Our ref SMI003/0002/4150-3671-2024/1/MC
10 February 2025

Land at Bird in Eye Farm – Consultation Response to Application WD/2024/1799/MAO and Written Representations to Appeal APP/C1435/W/24/3356658

ANNEX 3 – APPEAL REVISED ACCESS DRAWING NO. 23138 001 REV B

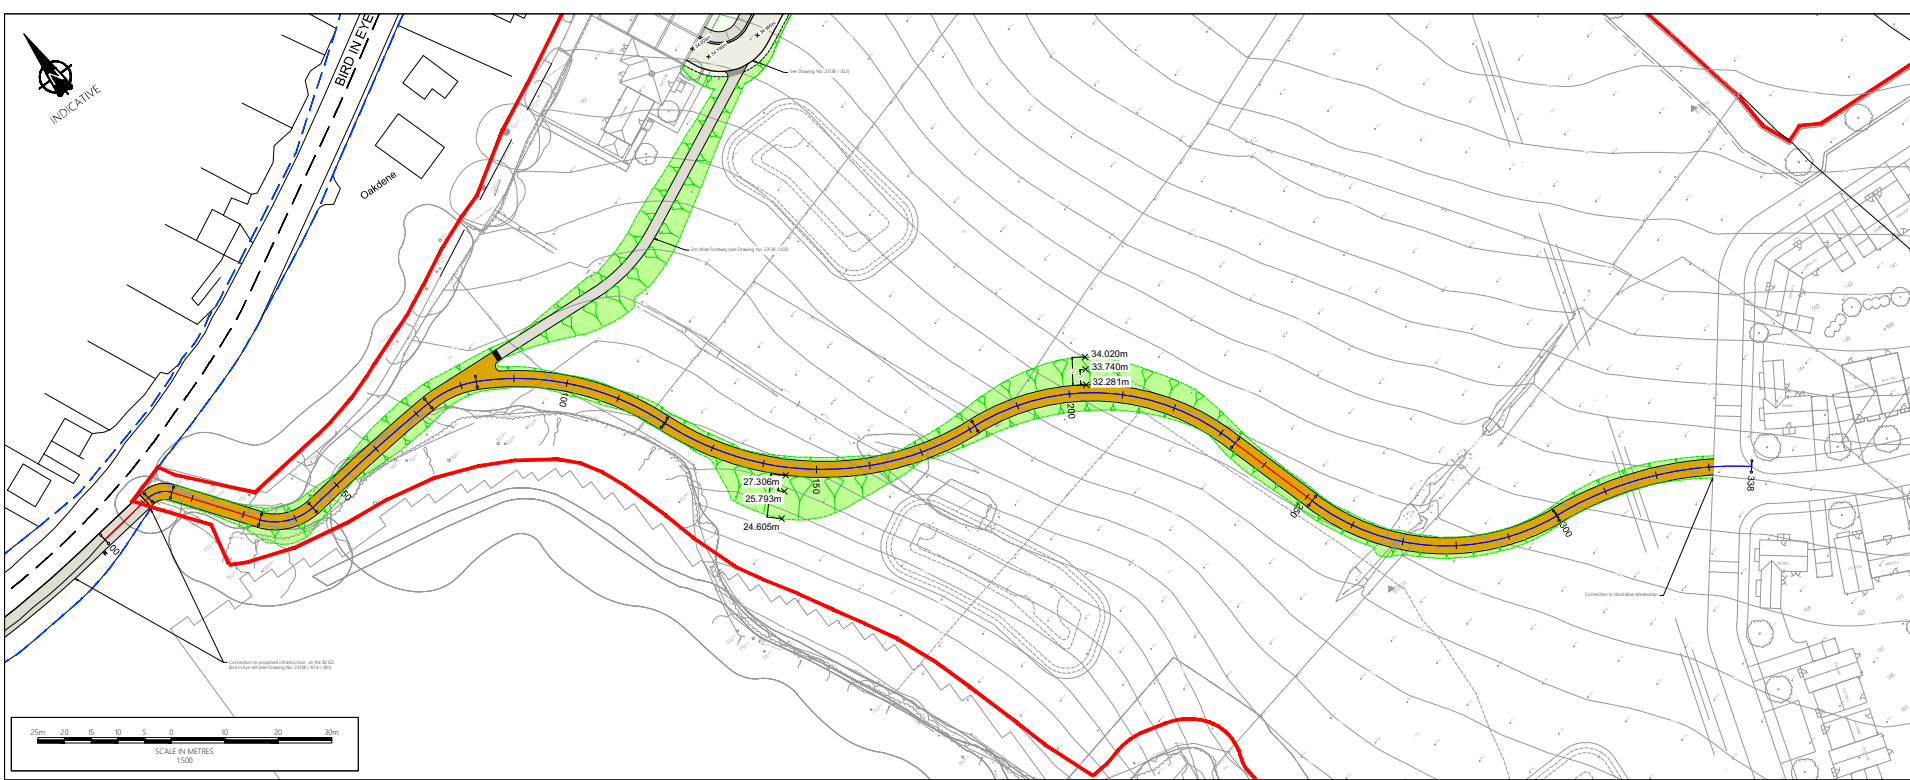
- 2.11 We note from the Wealden District Council (the "District Council") Statement of Case (SoC) available in respect of the Appeal that *"the required and necessary RSA was only undertaken on Monday 13 January 2025. The report was submitted to the highway authority on 20 January"*⁵. We also note that *"the RSA considered different, later, revisions to the proposed scheme drawings than were part of the submitted application or the appeal submission. The junction design drawing considered in the RSA was Drawing No. 23138/001 Revision B which differs from the submitted Revision A"*⁶.

- 2.14 The proposed junction design included in the Application and the Appeal is shown on Drawing 23138/001 Rev A, included at Appendix 7 to the Transport Assessment and Drawing 23138/001 Rev B included within the Stage 1 RSA. The key difference between the two drawings appears to be inclusion of the extent of adoptable highway proposed and the extent of public highway boundary in Drawing 23138/001 Rev B.

- 2.15 We have reviewed the proposed design and make the following observations:
- (a) There is a clear lack of deflection for the west to east movement from Bird In Eye Hill west to Bird In Eye Hill East raising a highway safety concern regarding the risk of vehicles failing to reduce speeds on the approach. This seems to be the result of a narrow highway verge and insufficient highway land to allow for proper deflection. In other words, drivers travelling east and west are less likely to be aware of the presence of the roundabout, and to slow down on the approach to it, especially in the dark. The Stage 1 RSA identifies this problem stating that *"Eastbound or westbound drivers on Framfield Road will have a clear view ahead and may, particularly at night, overshoot the junction"*⁷. However, it is most surprising that the RSA concludes that this issue can be dealt with later at the detailed design

stage by inclusion of signage and road markings; this is no substitute for adequate deflection. We know currently that traffic in both directions is travelling in excess of 30 mph. We do not know if the speed limit will be reduced, and the County Council note in their response that such a speed limit reduction would not be supported. The designer's response is inadequate in our view and relies upon adequate deflection which is **not** provided.

- (b) There appears to be mixed provision for cyclists entering the roundabout from the east in carriageway, before exiting the circulatory carriageway on the eastern side and linking in to several convoluted informal crossings points with tactile paving to access the development via a shared footway/cycleway running along the western side of the access road. There is no demonstration that cycle provision for the proposed scheme and access junction is compliant with LTN 1/20, which is a Department for Transport (DfT) national guidance document that details standards expected of new cycle infrastructure. The Stage1 RSA identifies this issue identifying a risk of pedestrians/ cyclists "*inadvertently entering the carriageway*" and "*being struck by a passing vehicle*" ⁸. The designer's response is wholly inadequate. This issue needs to be addressed now.

- (c) The roundabout appears to rely on a change in speed limit to 30mph which is outside the control of the planning system and would require separate approval from both the County Council and the Police. No information is included with the Application or Appeal documentation to demonstrate that the proposed junction design works at alternative speed limits i.e. if the proposed speed limit change is not approved.

- (d) The junction design does not appear to offer street lighting as part of the proposals, and it is unclear how a street lighting scheme can be incorporated both in terms of land within the Appellants control and/or public highway and in terms of the potential impact that this street lighting would have on the heritage assets including the setting of the Grade II Listed Oast House. The Stage 1 RSA identifies the lack of street lighting and raises concern regarding a "*risk of collisions particularly at night*" ⁹. The designer's response accepts such a scheme is necessary, but no design is forthcoming. This should be addressed now so all the consequential environmental impacts can be assessed.

- (e) There appear to be significant earthworks required to deliver the proposed junction design, with embankments shown on some drawings. However, no detailed information on the required earthworks is provided within the Application or Appeal material and no detailed information on the levels/ carriageway gradients is provided.

- (f) There appears to be a significant retaining wall structure needed on the eastern side of the proposed roundabout in order to deliver the proposed junction design. However, there is little information in the Application or Appeal documentation, none that shows the structure in detail or that considers the impact of the structure, or its construction, on relevant ecology, the adjacent woodland or the setting of the Grade II Listed Oast House.

SHARED LINK - LONGSECTION
SCALE: H 1:500,V 1:500. DATUM: 20.000

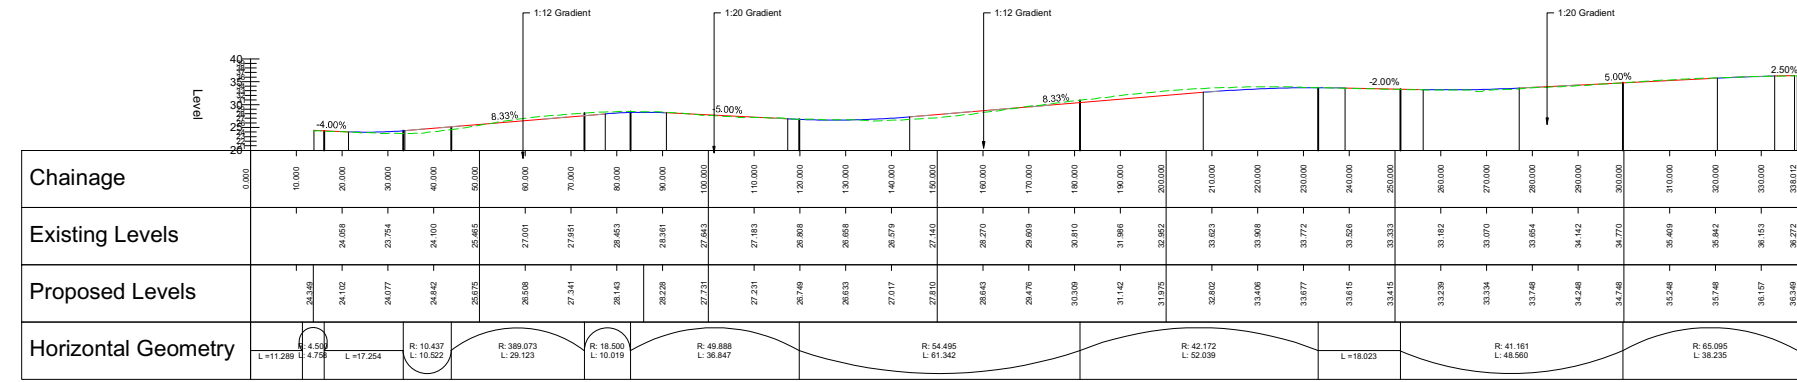
3.7 Gradients for the proposed western footway/ cycleway link are shown in the long section on Drawing 23138/004 Rev A (Annex 4) and show that the gradient of the proposed route would vary between 1:20 and 1:12. This section indicates that gradients of 1:12 will be experienced over lengths of some 50m or more along the route, relaxing to 1:20 and then increasing again.

3.9 The guidance does offer some flexibility over short distances, defined as “1000mm or less”,¹⁵ where the absolute maximum gradient advised is 1:12. The Transport Assessment provides no demonstration of how the gradients along the proposed footpath are acceptable, particularly for those with mobility impairments, pushchairs or carrying heavy shopping bags.

- 3.10 There do not appear to be any rest places provided along the 338m length of the footpath leading between Bird In Eye Hill and the residential development area.
- 3.11 The gradients of this route, combined with its remoteness and lack of overlooking, raise a further significant concern regarding the sustainability/ accessibility of the Appeal Scheme.
